## PIC24FJ64GA004 Family Silicon Errata and Data Sheet Clarification

The PIC24FJ64GA004 family devices that you have received conform functionally to the current Device Data Sheet (DS39881D), except for the anomalies described in this document.

**FIGURE 2-3 FREQUENCY vs. ESR PERFORMANCE FOR SUGGESTED VCAP**

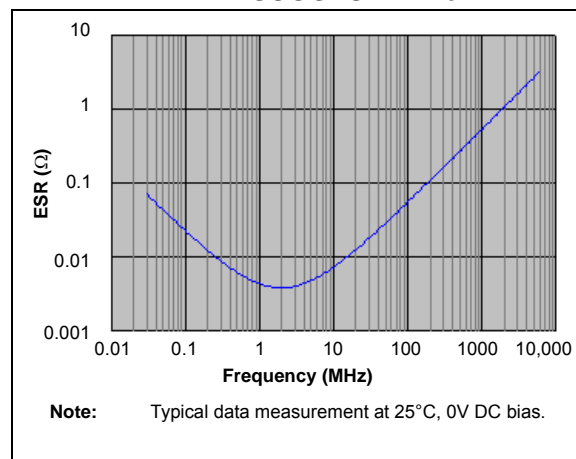
Designers may use [Figure 2-3](#) to evaluate ESR equivalence of candidate devices.

When the regulator is disabled, the VCAP/VDDCORE pin must be tied to a voltage supply at the VDDCORE level. Refer to **Section 27.0 “Electrical Characteristics”** for information on VDD and VDDCORE.

**FIGURE 2-4 DC BIAS VOLTAGE vs. CAPACITANCE CHARACTERISTICS**

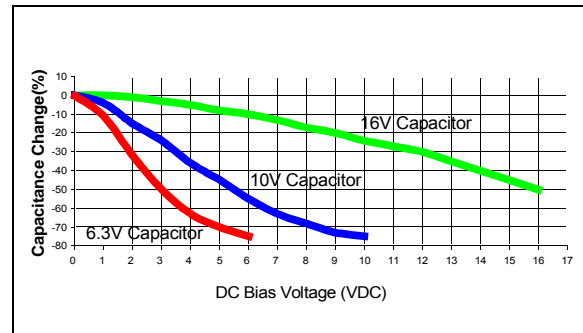
A typical DC bias voltage vs. capacitance graph for 16V, 10V and 6.3V rated capacitors is shown in Figure 2-4.

When selecting a ceramic capacitor to be used with the internal voltage regulator, it is suggested to select a high-voltage rating, so that the operating voltage is a small percentage of the maximum rated capacitor voltage. For example, choose a ceramic capacitor rated at 16V for the 2.5V core voltage. Suggested capacitors are shown in Table 2-1.
